**ELECTRICAL ADDENDUM #E-1
VICKER'S KITCHEN AND DINING FACILITY
CFB BORDEN
MAY 29, 2013**

The following document is hereby made a part of the Contract Documents.

The following revisions and/or additions shall be made to Drawings and/or specifications and the cost shall be included in Tender Price.

DRAWING H-B147-3803/1-593 (not-issued)

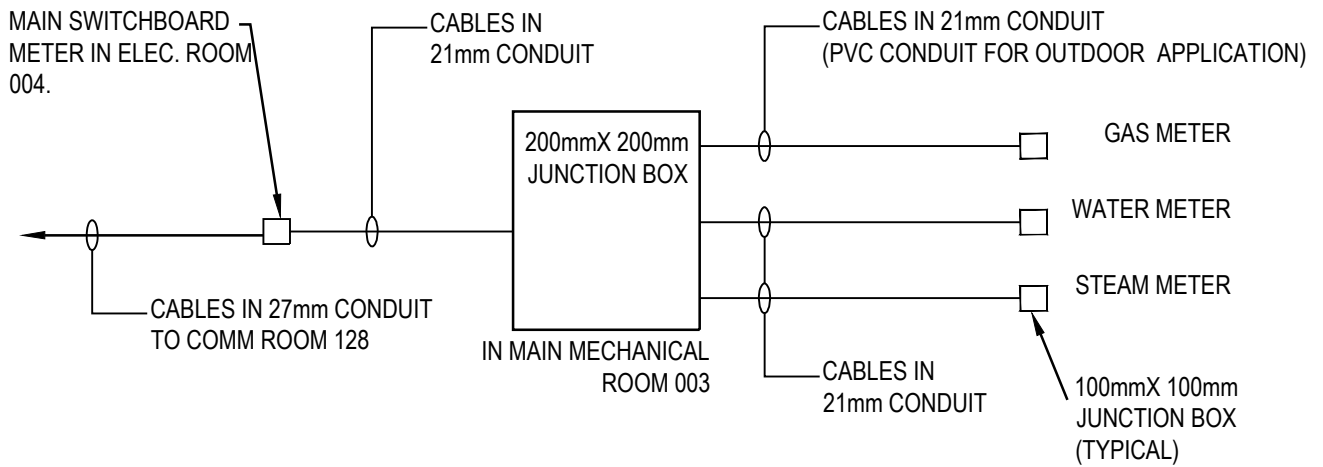
1. Revise Panel 'B2' to suit revisions made to Drawing 533.

REMOTE METER MONITORING SCHEMATIC

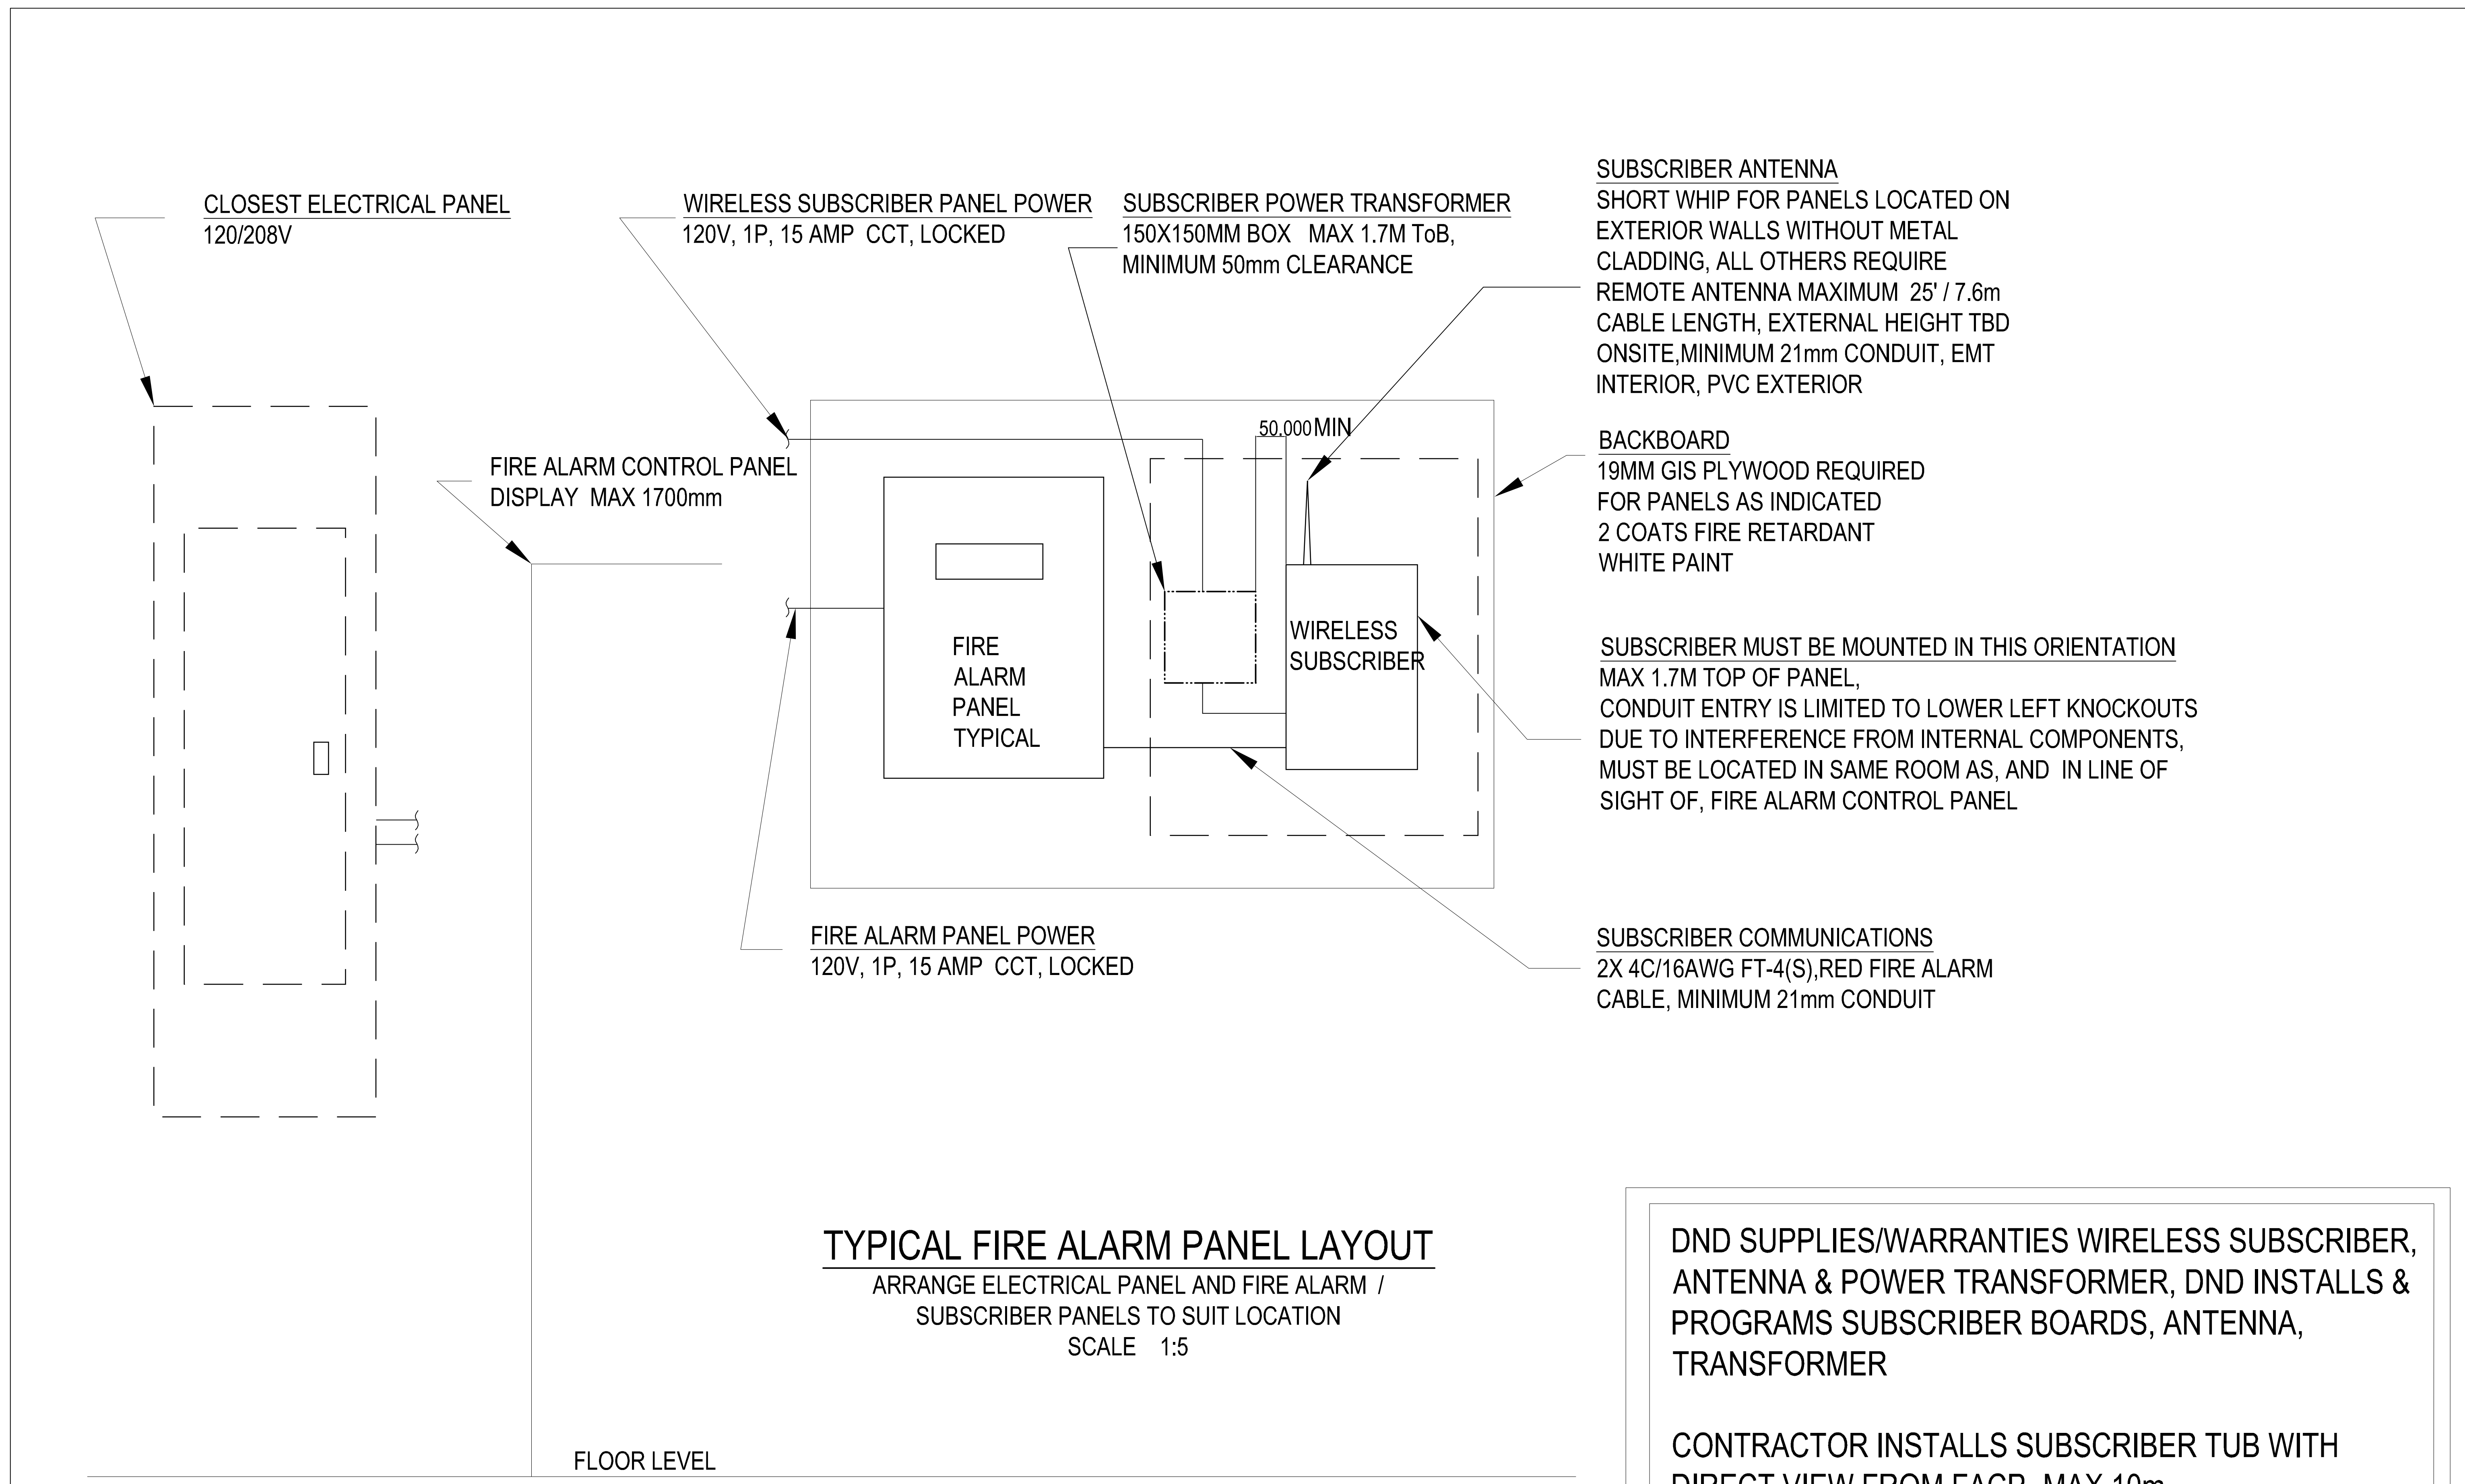
1. Provide conduits for Remote Meter Monitoring System as per attached Sketch ESK-1.

1. THE CABLE TYPE FOR REMOTE METER CONNECTION IS 18-2 BELDEN, TWISTED PAIR; SHIELDED.
2. 100X 100MM JUNCTION BOX MOUNTED NEAR EACH METER (WITHIN 1M) WHERE THE RIGID CONDUIT WILL TERMINATE AND THEN DND WILL MAKE THE FINAL CONNECTIONS WITH FLEX-TITE RUN FROM THE J-BOX TO THE PULSE METER CONNECTION POINT.
3. CONTRACTOR SHOULD LEAVE 3M COIL OF BELDEN 18-2 AT EACH J-BOX AND AT THE MAIN ELECT METER LOCATION.
4. CO-ORDINATE ON SITE WITH METERS AND JUNCTION BOXES EXACT LOCATIONS PRIOR TO ROUGH-IN..
5. WIRE SYSTEM IN ACCORDANCE WITH SUPPLIERS INSTRUCTIONS.
